## STAFF REPORT

### CRITICAL AREA DETERMINATION

<b>Project No.:</b>	CA019-004
<b>Description:</b>	Request for a critical area determination to average the buffer of a Type 2 watercourse in order to construct a new single-family dwelling. The applicant is proposing to conduct development activity within 478 square feet of the watercourse's buffer, while adding 500 square feet to the buffer elsewhere on the property.
<b>Applicant / Owner:</b>	Michael McFadden (Stuart Silk Architects) / Alexandra Boyle and Charles Lee
<b>Site Address:</b>	4150 Boulevard Place, Mercer Island, WA 98040; Identified by King County Assessor tax parcel number 362350-0174.
<b>Zoning District:</b>	Single Family Residential (R-15)
<b>Staff Contact:</b>	Andrew Leon, Planner
<b>Exhibits:</b>	<ol style="list-style-type: none"><li>1. Development Application, dated March 7, 2019</li><li>2. Development Plan Set, received by the City of Mercer Island on March 7, 2019</li><li>3. Project Narrative, dated March 7, 2019</li><li>4. Critical Areas Report, received by the City of Mercer Island on March 7, 2019</li><li>5. Peer Review Memorandum prepared by Environmental Science Associates, dated May 10, 2019</li><li>6. Bon

CRITICAL AREAS DETERMINATION  
SITE PLAN

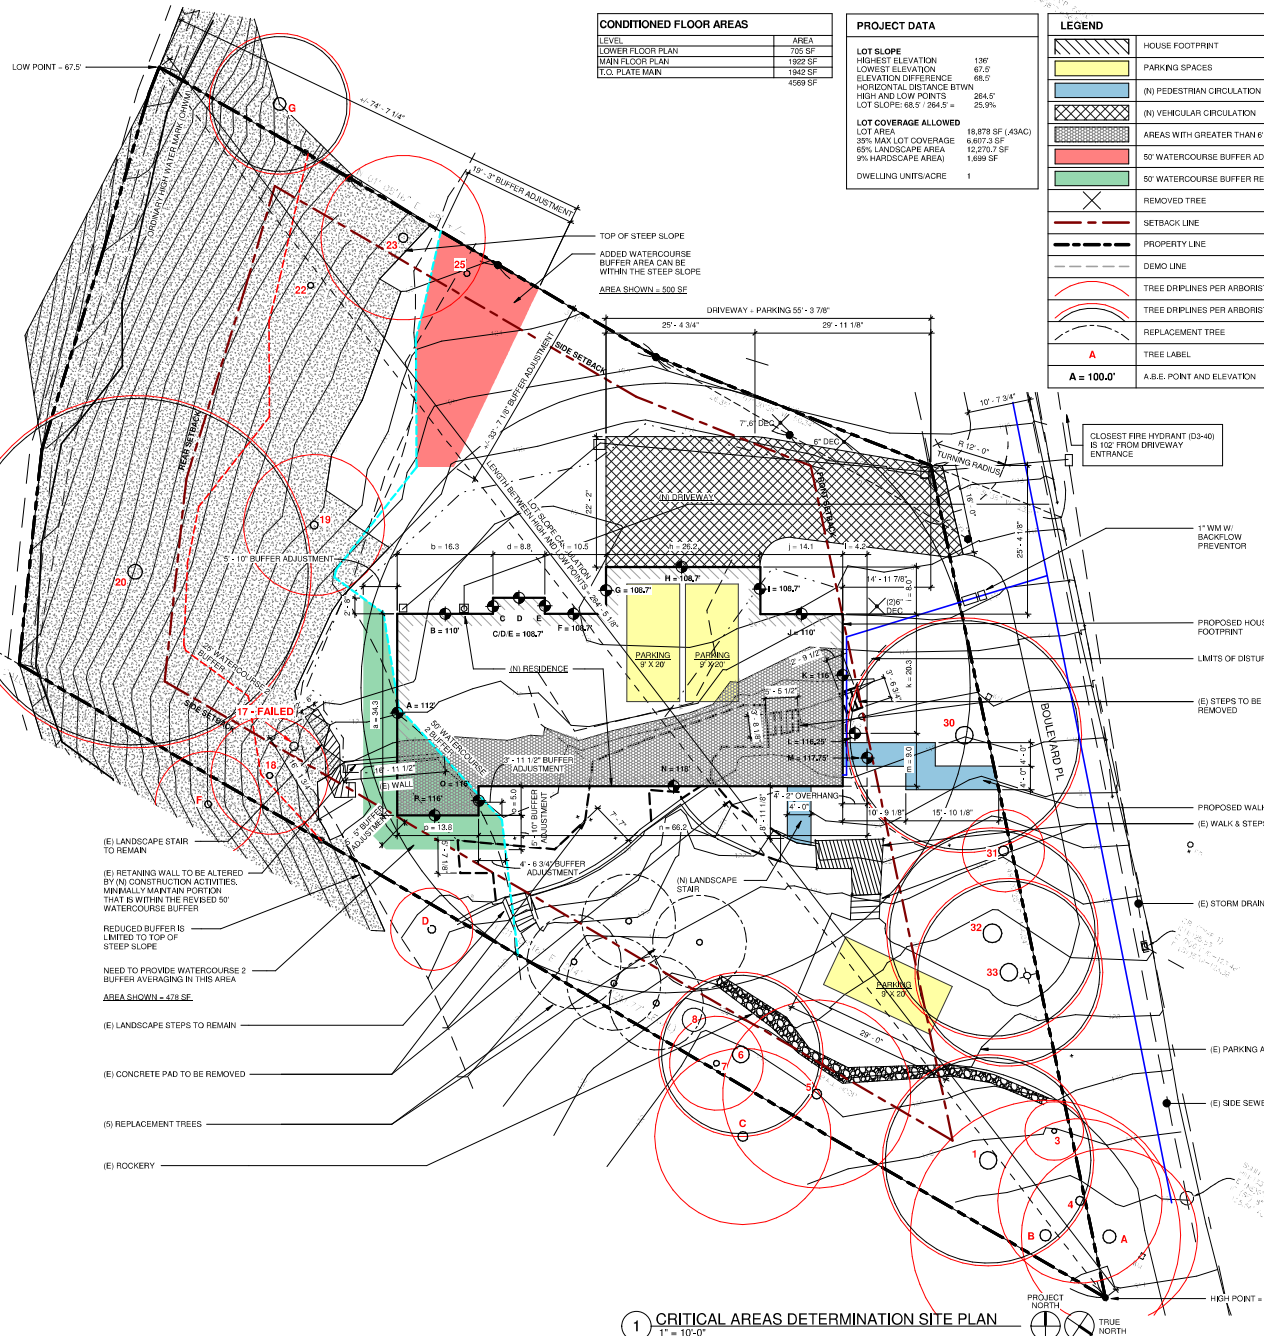
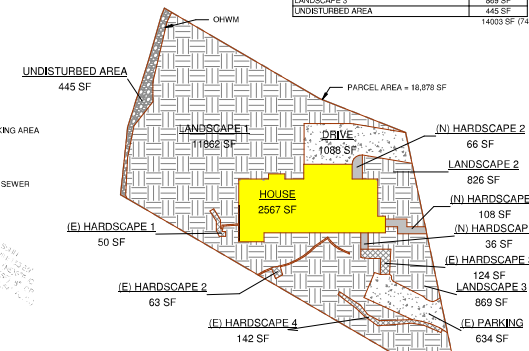
**Staff Analysis:** Sheet CA-1.0 of Exhibit 2 shows that the buffer is being reduced by 478 square feet on the east side of the lot, while 500 square feet is being added to the buffer on the west side of the lot. The total area of the buffer will not be reduced below the area of the buffer if it were not averaged, thereby meeting this criterion.

**Staff Analysis:** As shown on sheet CA-1.0 of Exhibit 2, the proposed portion of the buffer to be reduced does not contain a steep slope. This criterion is met.
